**Deadline 3: Applicant's Response to Examining Authority's
Written Questions (ExQ1A)**

**Wheelabrator Kemsley (K3 Generating Station) and Wheelabrator Kemsley North
(WKN) Waste to Energy facility Development Consent Order**

PINS Ref: EN010083

Document 11.2
April 2020 - Deadline 3

Figure 1.35_1 RDF Exports from England, 2011 to 2020

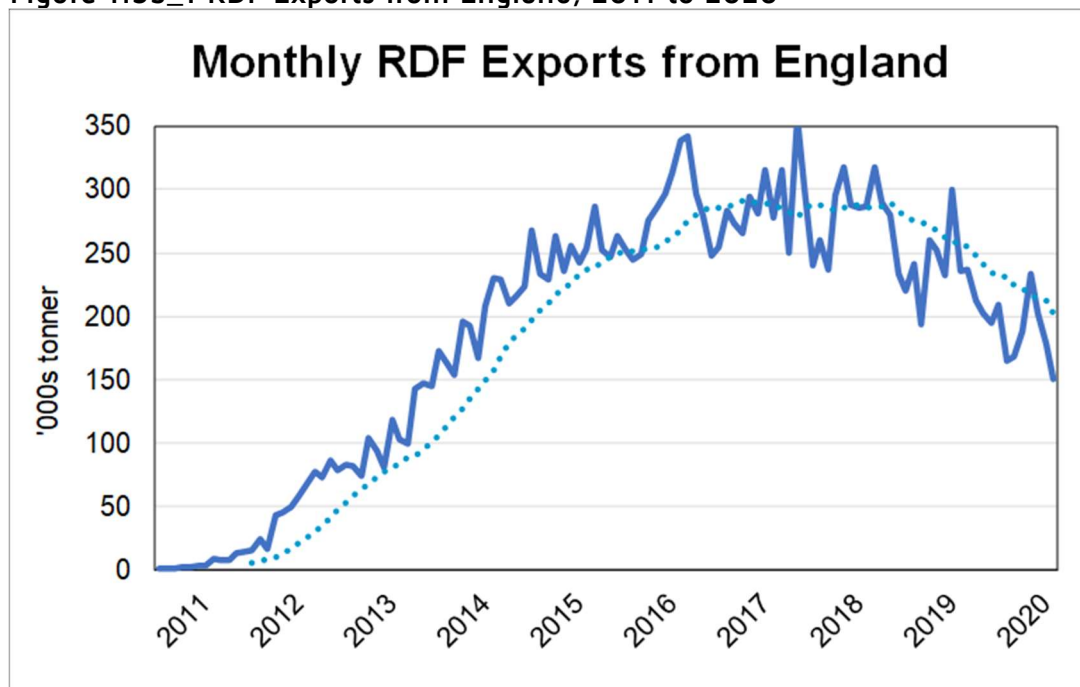
- 1.35 Q1A.1.35 – Applicant - With regard to export of RDF overseas, now that the UK has left the EU please provide an update, if any, of paragraph 3.4.8 in WHFAR [APP-086] , and elaborate upon paragraph 61 of Applicants comments on written representation [REP2-011], indicating what evidence indicates the export of RDF waste would be negatively affected.**

- 1.35.3 Figure 1.35_1 shows a plateau in the tonnage exported (of around 3 million tonnes) over the three-year period March 2016 to March 2019. It also shows a general decline from 2018.

- 1.35.4 There are a number of reasons why this practice grew so suddenly, and is now in decline. Primarily, it made economic sense for RDF to be exported. As identified in the WHFAR [APP-086] (from paragraph 2.4.7) WRAP¹⁰ publishes an annual Gate Fee Report¹¹. Not only do these reports consistently show that gate fees at material recycling facilities and organic waste treatment facilities (e.g. anaerobic digestion facilities) which are preferred in the waste hierarchy, are significantly lower than gate fees at energy from waste plant and landfill facilities; they also show that the cost of landfill (including tax) was £76 per tonne in 2011, and rising. Gate fees across European energy recovery facilities,
